Access Compliance Report Public Rights-of-Way (Curb Ramps)

Intersection ID: 50605 Main Street: DENBUR DR Cross Street: RHODORA RD Location: NW Initial Pass/Fail: Fail **Overall Compliance: No Severity Score:** 10 **ADA ID: 01C2411FF5FF** Ramp Type: Perp

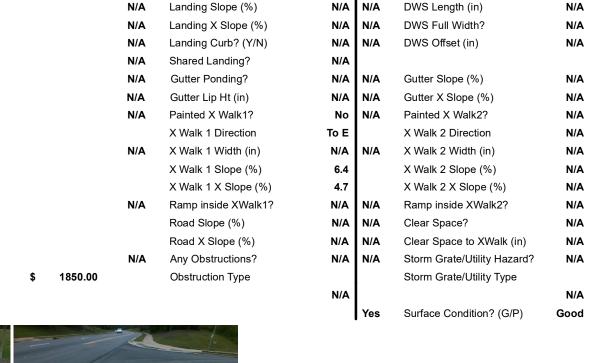
DENBUR DR Street 1 Name Stop Condition-Street 2 None N/A Street 2 Name Stop Condition-Street 1 N/A Possible Solutions: Remove & Replace Entire Ramp. Surveyor Notes: N/A PROW/ADA: Not Found, R304.5.1
